**CITY OF MERCED PROJECT NO. CP220061
CHANGE ORDER NO. 2**

PROJECT NAME: Community Park 42

Additional work to add underground electrical, water. Quantity adjustment for additional asphalt per the contract unit price.

REQUEST FOR INFORMATION

REF. SPECIFICATION:
Bid Item #23 - 6" Sewer
DRAWING: C2.1, C2.2, C2.3, C2.4,
C2.5, C2.6

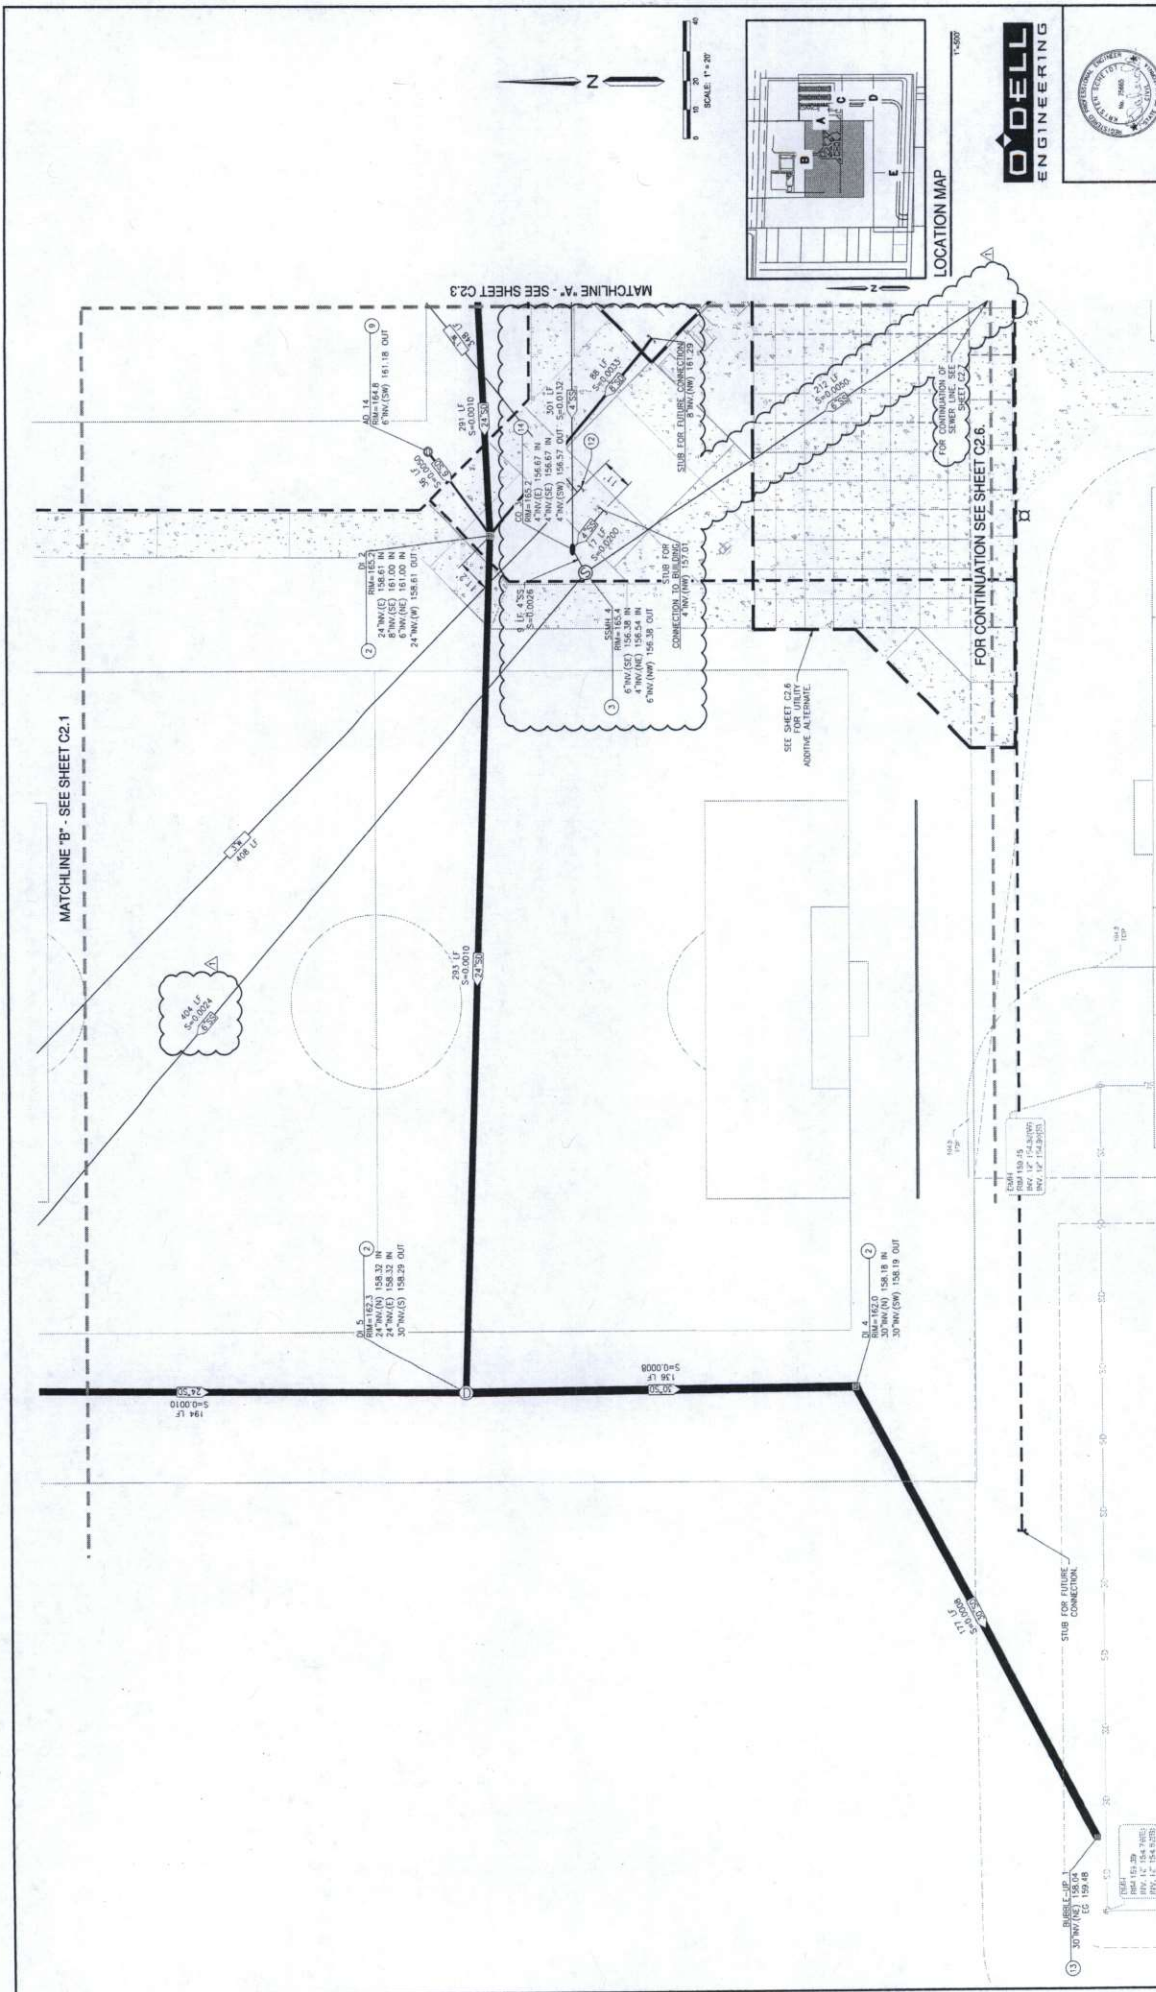
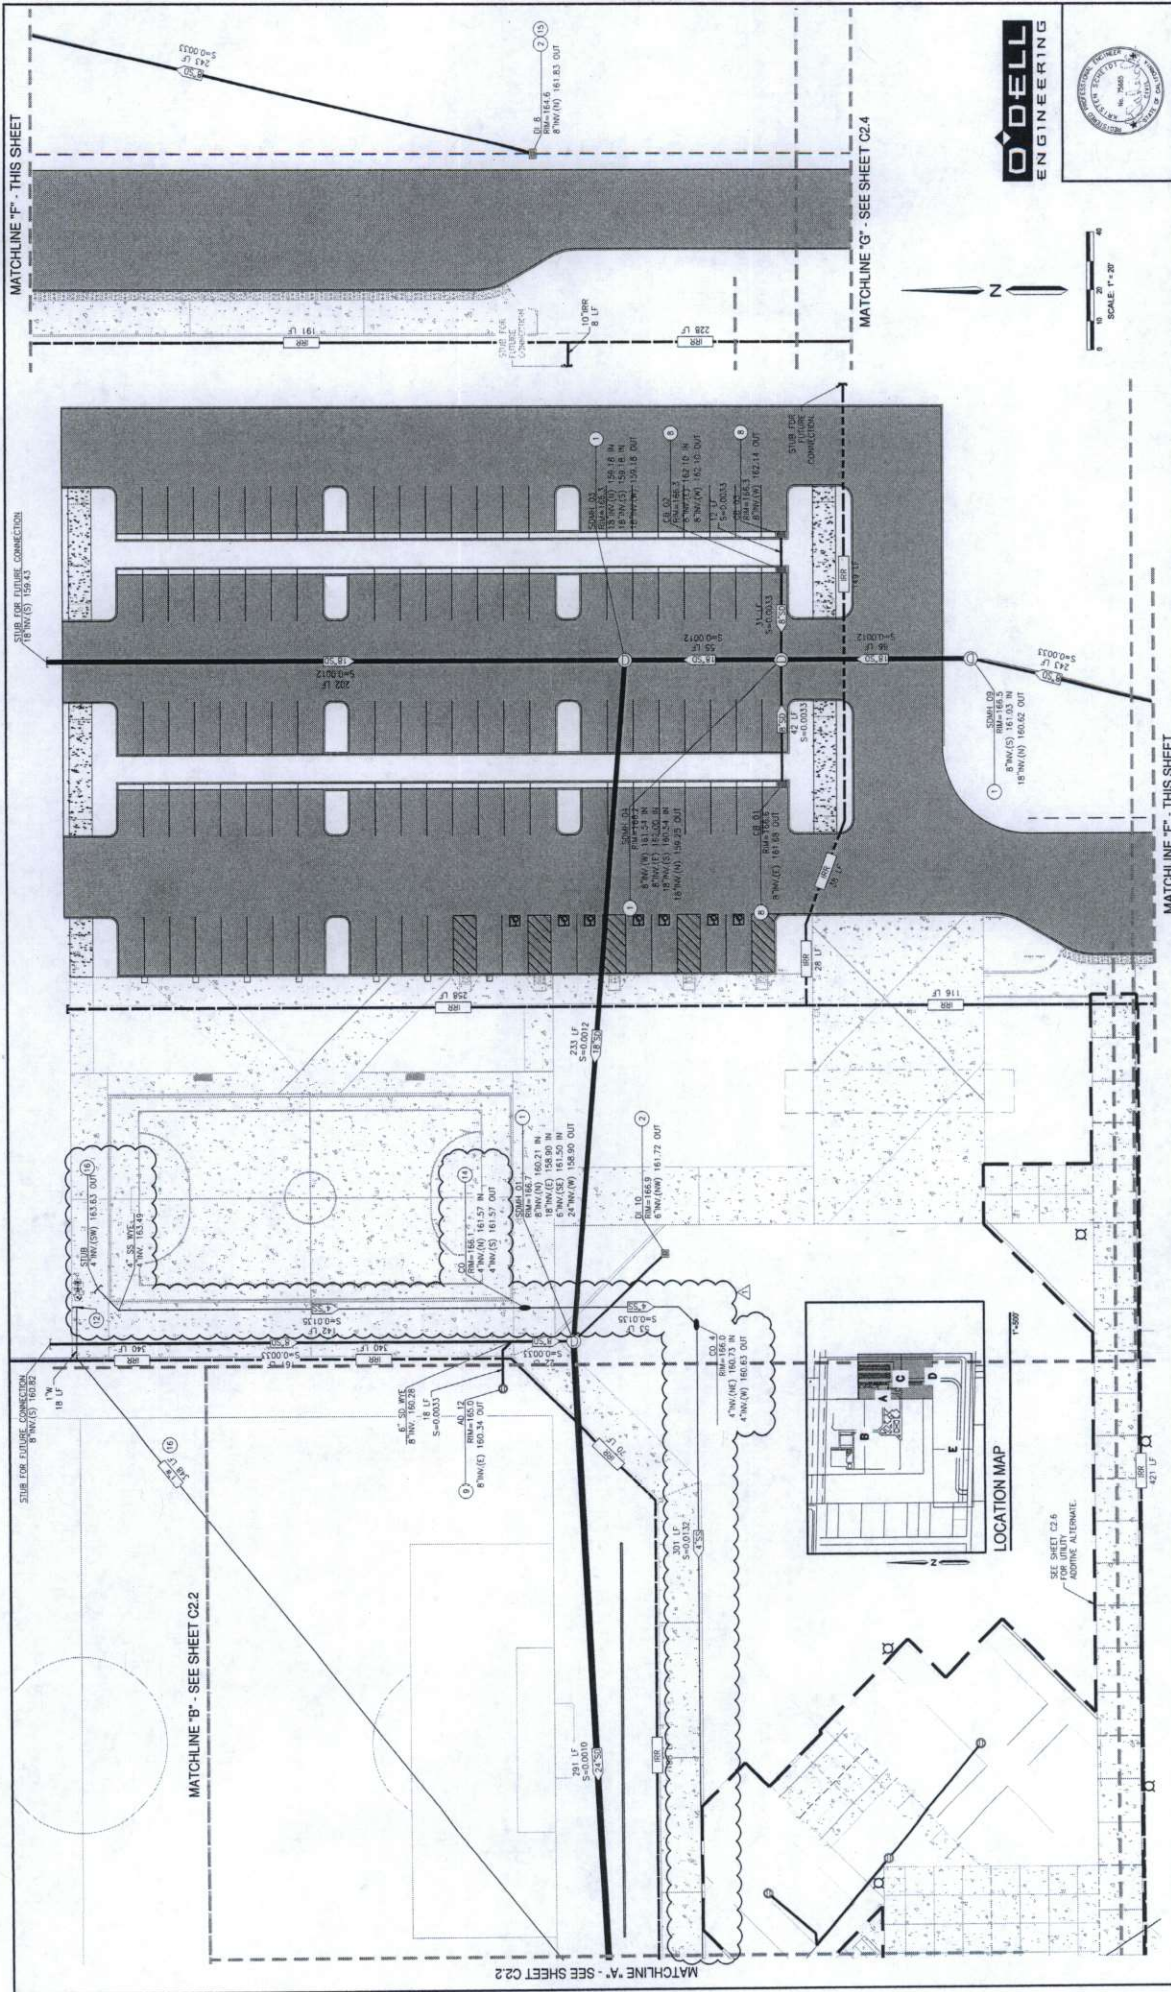
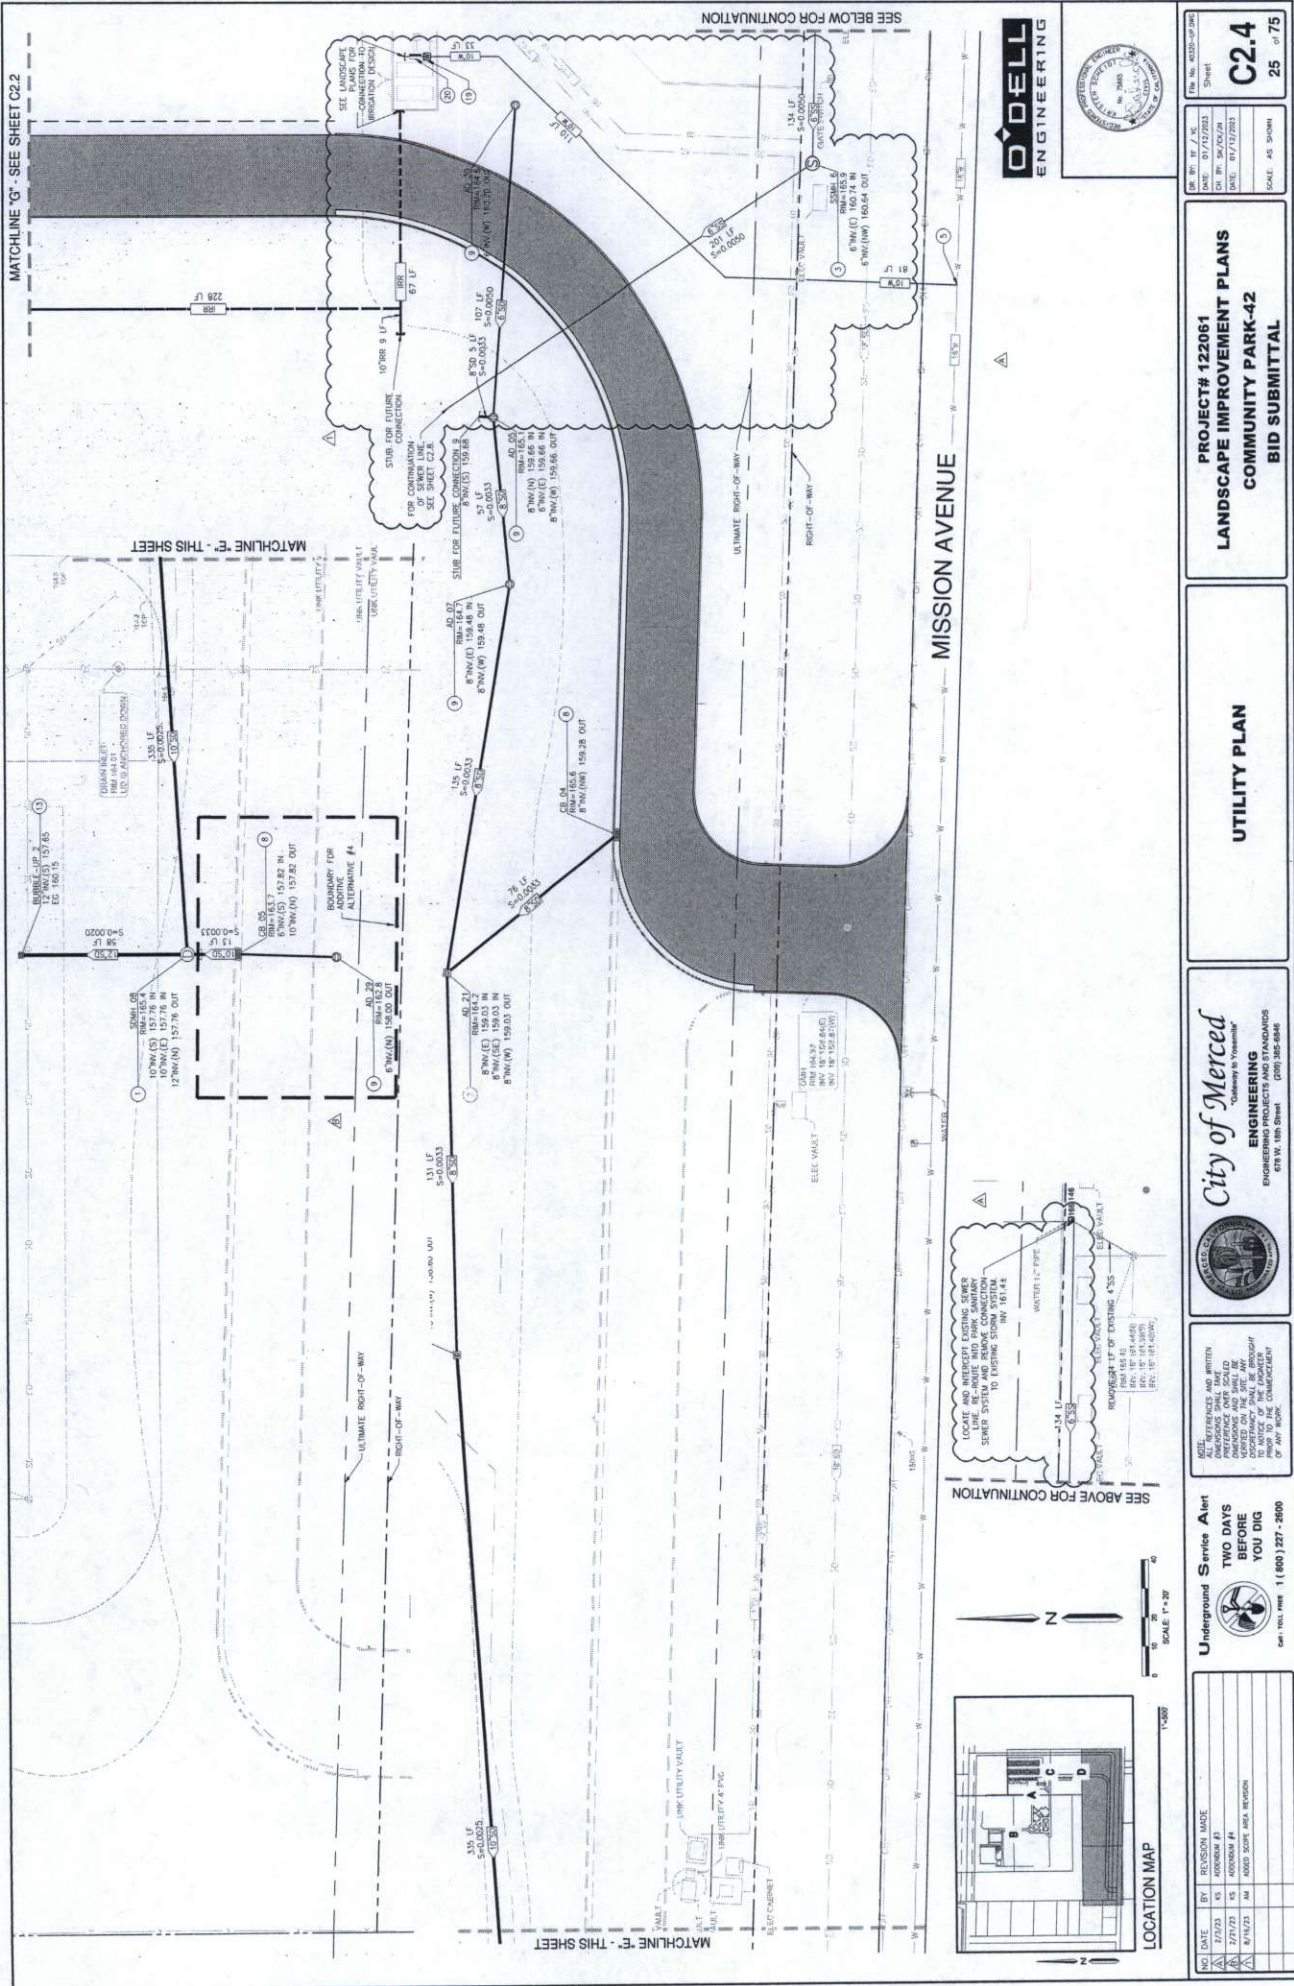
REQUEST: Bid Item # 23 - 6" Sewer shows a quantity of 1,170 LF. When we preformed our take off, we found 2,830LF shown on the plans. That's an additional 1,660LF. Please verify quantities.

REPLY: See sheets C2.1 to C2.5 and C2.7 to C2.8 Rev 1 dated 8/16/23 showing revised sewer line routing between concession building and well site 20. Line item 23 on Bid Schedule A to be updated to 2,561 LF.
